Service Bulletin

Bulletin No. 2010-71
CMD 2010-11

Steering Actuator Inner Oil Seals

44058

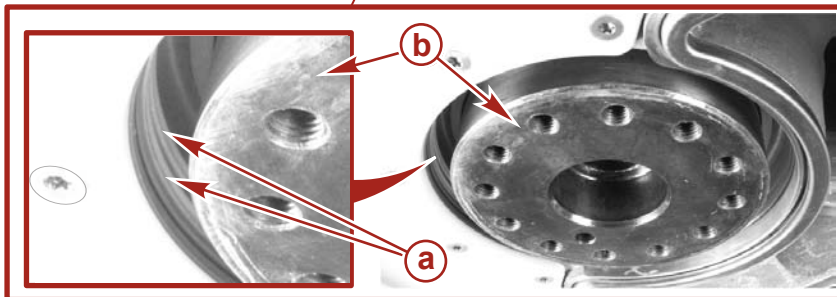
Zeus drives use two seals between the king pin adapter plate and the steering actuator housing. These steering actuator inner oil seals keep gear lube in the drive and water out of the drive at the swivel joint of the king pin adapter and the steering actuator.

Cummins MerCruiser Diesel now offers replacement seals for the steering actuator housing. The inner oil seals are now available separately and are serviceable if a leak is detected between the kingpin adapter plate and the steering actuator housing.

A leak at this joint will cause the lube level to rise continually in the gear lube monitor. The lube will have a milky appearance because of water mixing with the gear lube. In some cases, the gear lube may be pushed out of the cap on the gear lube monitor.

If the lube level is rising and the gear lube appears milky, use the following procedure for determining whether the steering actuator inner seals are leaking.

Pressure-test the drive assembly following the procedure in the appropriate CMD service manual (#45 or #52).

1. If the drive holds pressure and yet the lube is milky and the level is rising, the steering actuator inner seals should be replaced. Inner oil seals may hold pressure when tested, then leak during vessel operation. Leaking seals must be replaced. Service literature has been updated and provides the procedures necessary to replace the seals.
2. If the drive assembly does not hold pressure, remove the gear housing and pressure-test the gear housing. This test will determine whether the problem is with the gear housing or with the steering actuator seals. If the leak is with the gear housing, repair according to the service manual. The steering actuator seals are not the source of the problem.
